CITY OF ALBUQUERQUE PUBLIC WORKS DEPARTMENT	
TITLE: COPPER PARK SUBDIVISION GRADING & DRAINAGE PLAN	
DESIGN REVIEW COMMITTEE	CITY ENGINEER APPROVAL
MO./DAY/YR.	MO./DAY/YR.
LAST DESIGN UPDATE	HYDROLOGY SECTION
CITY PROJECT NO.	ZONE MAP NO. K-22-Z
SHEET 1 OF 1

COPPER PARK SUBDIVISION
DRAINAGE CERTIFICATION

TITLE: **COPPER PARK SUBDIVISION
GRADING & DRAINAGE PLAN**

CONCRETE CHANNEL SECTION

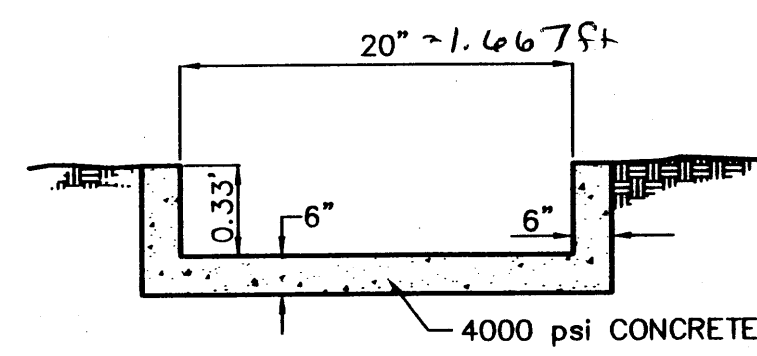
Calcs of channel capacity?

prev design
 $A = 2\left(\frac{1}{2}\right)(0.55)(0.665) = 0.3325 \text{ ft}^2$

N.T.S.
 $A = (0.33 \text{ ft})(20 \text{ ft})\left(\frac{1 \text{ ft}}{12 \text{ in}}\right) = 0.55 \text{ ft}^2$
Assume $S_{\text{still}} = 0.006$
Assume $n = 0.012$ (finished concrete)

N.T.S.
 $Q = 1.49 AR^{2/3} S^{1/2}$
 $Q = 1.49 (0.55)^{2/3} (0.006)^{1/2} = 0.236 \text{ cfs}$
 $Q = 2.02 \text{ cfs}$
 $Q_{\text{req}} = 0.93 \text{ cfs}$
